## ADDENDUM #3

**Date Issued: March 27, 2018**

**NEW HAVEN PUBLIC SCHOOLS  
SCHOOL CONSTRUCTION PROGRAM**

**A-324**

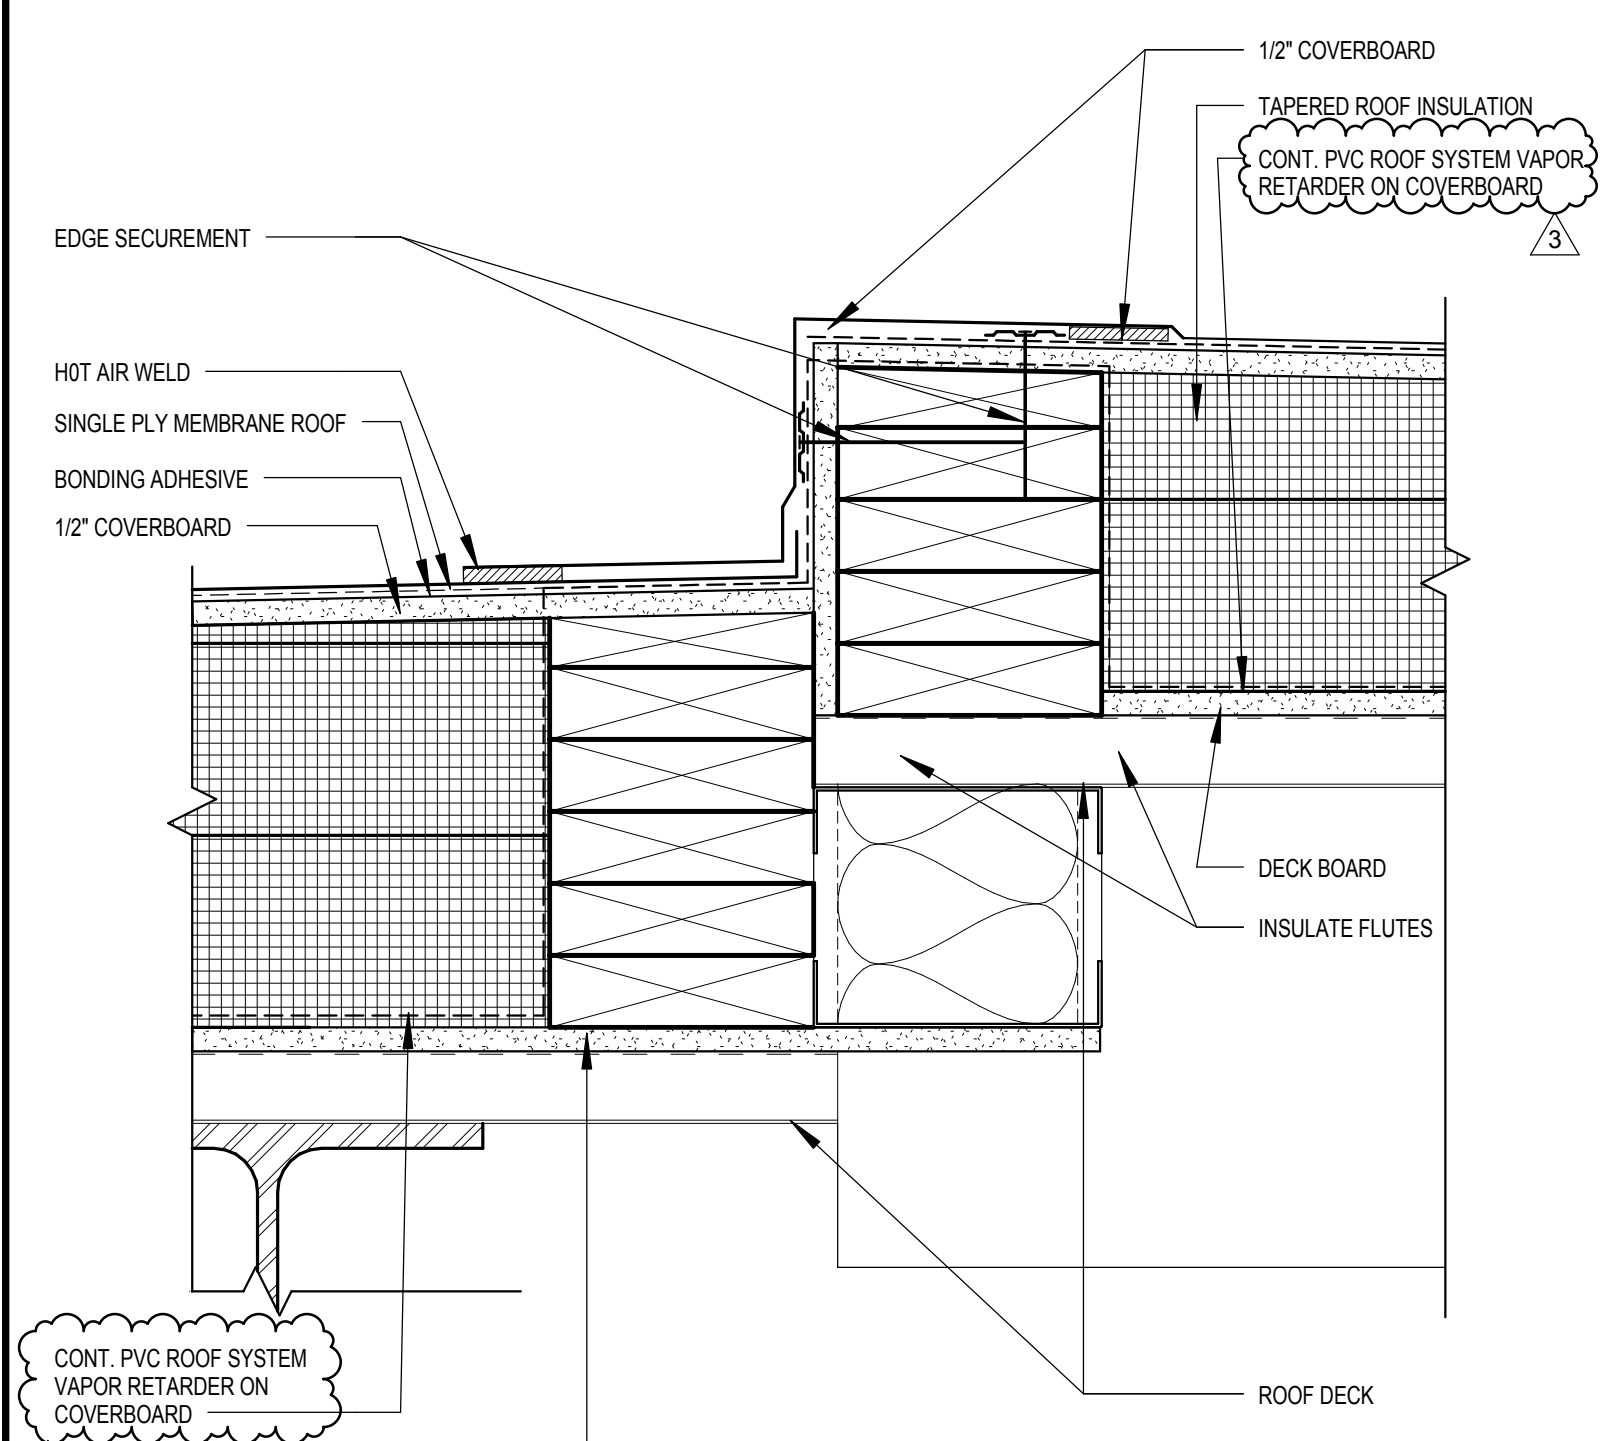
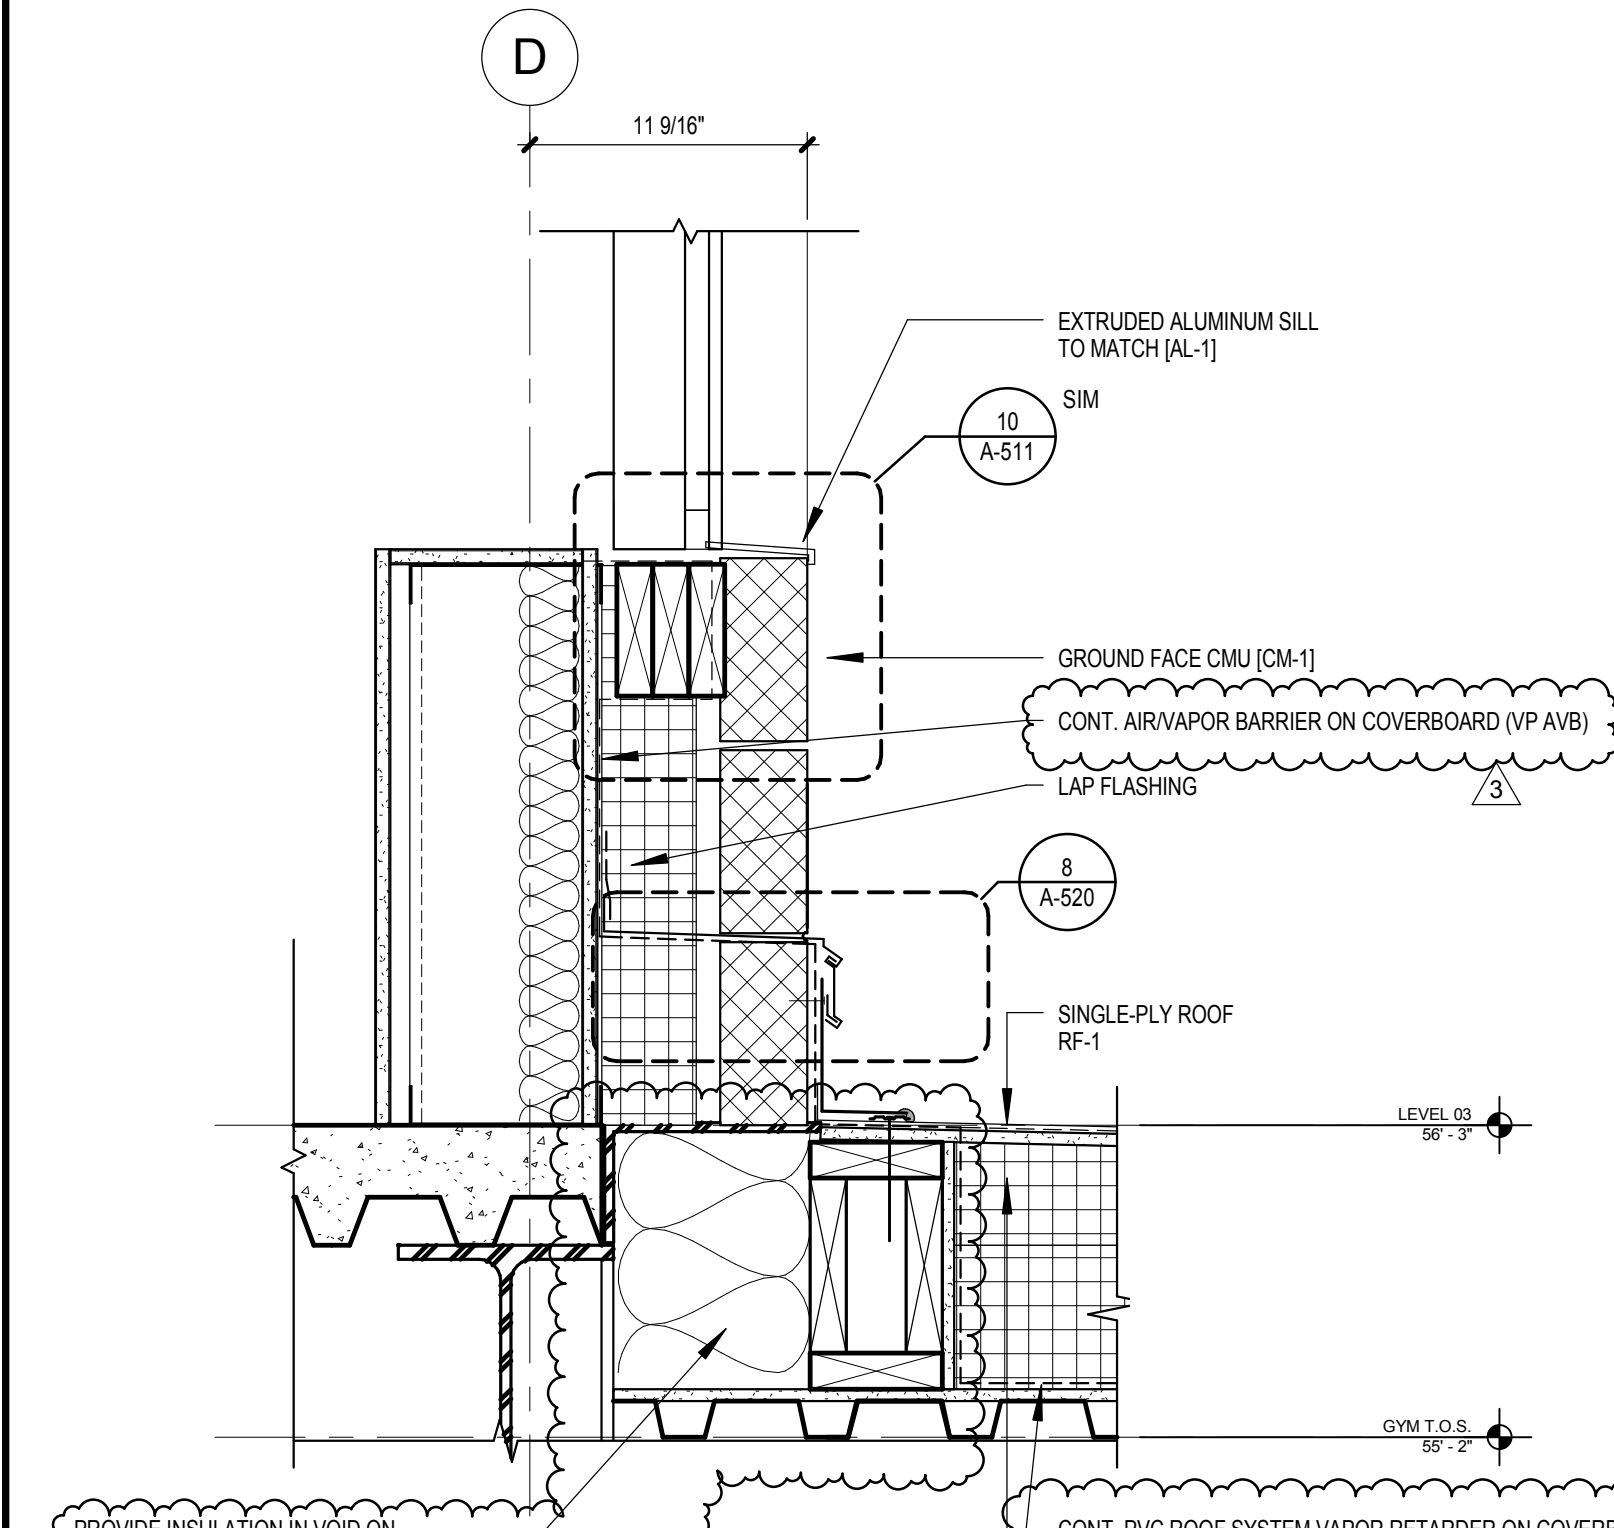
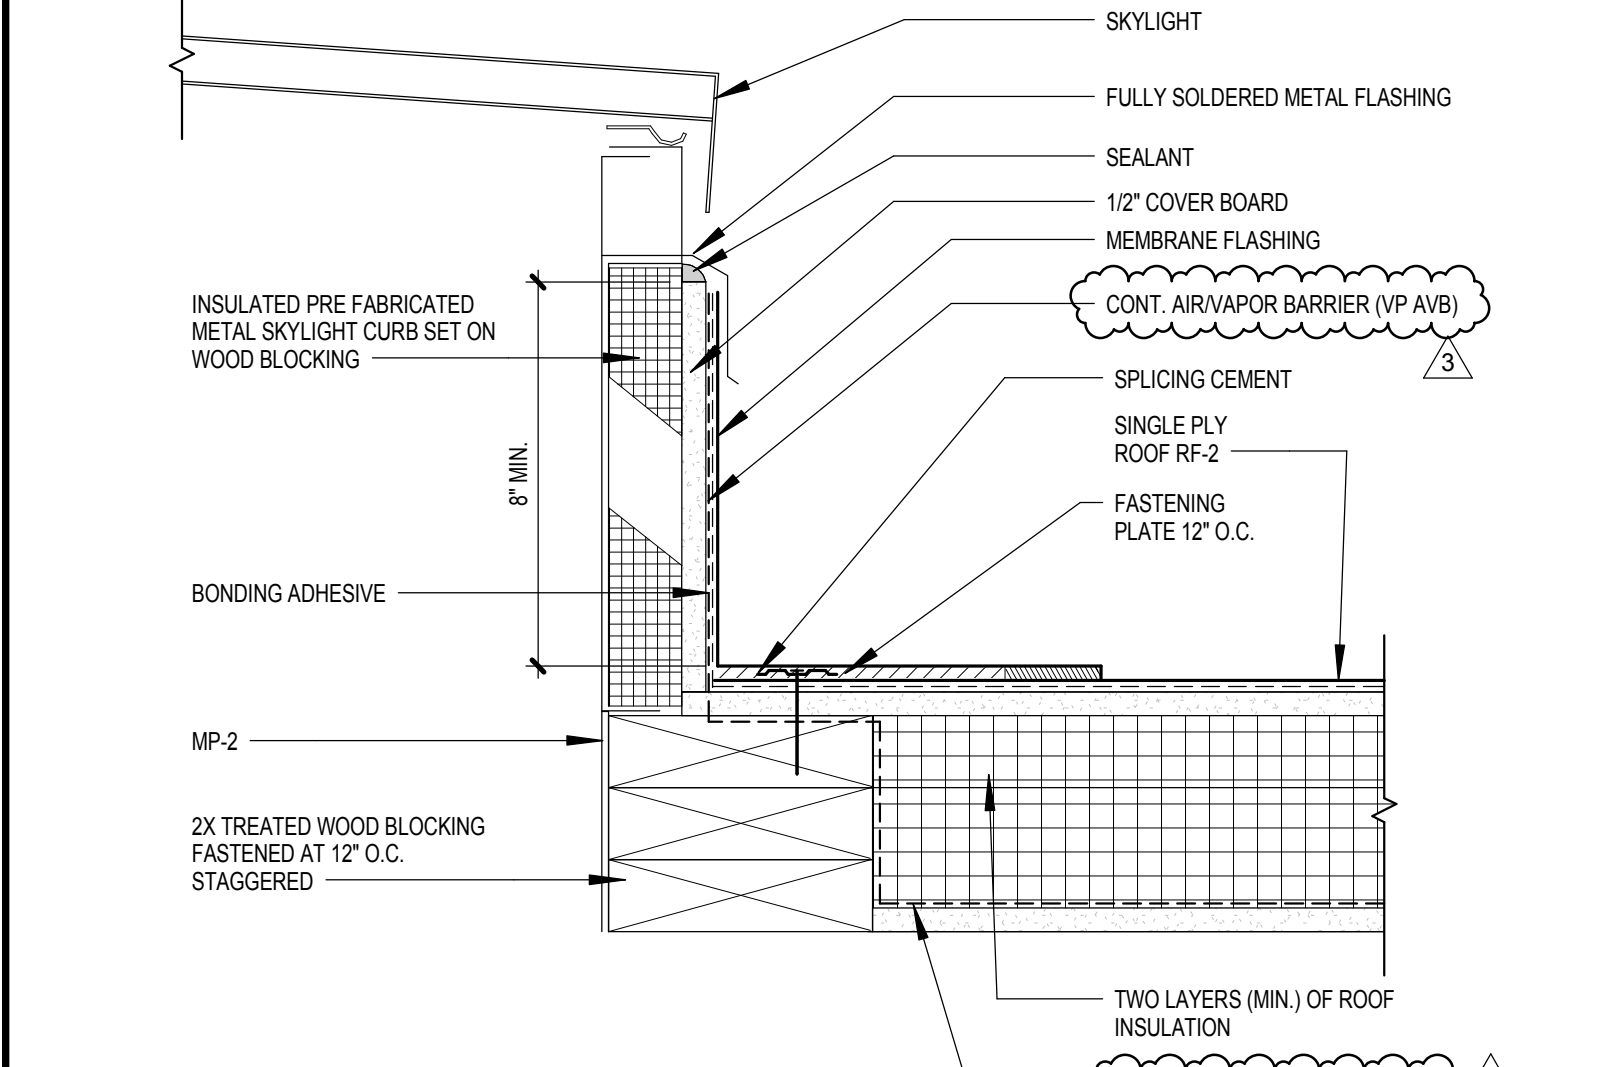
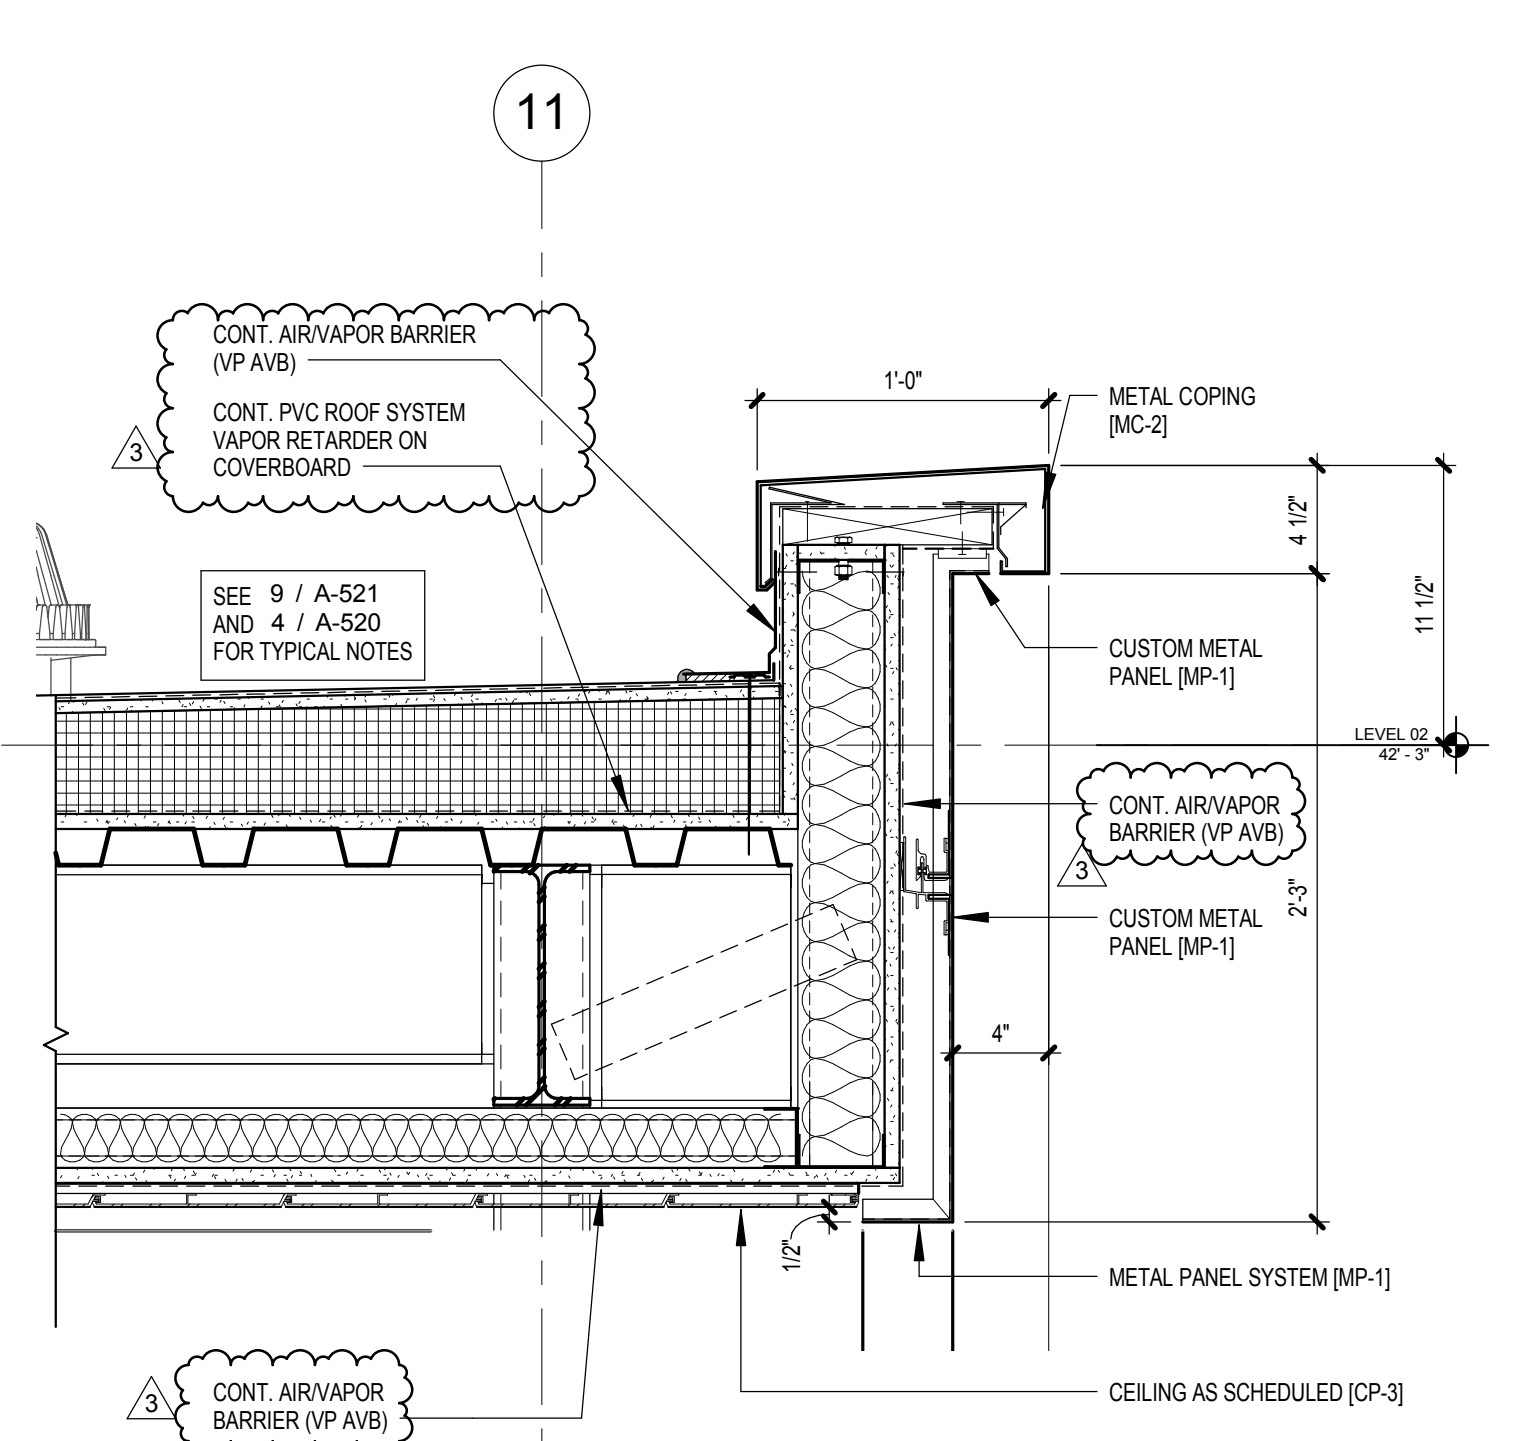
- A-324: Revised elevation 2 to add horizontal mullions at glazing panels.
- A-327: Added call out for detail 21/A-550.
- A-327: Revised detail 1 to match blow up detail 4/A-503 and added call out on typical condition.

See attached from specified manufacturer for section 084113.13. Frames on drawing A324 exceed their max height size.
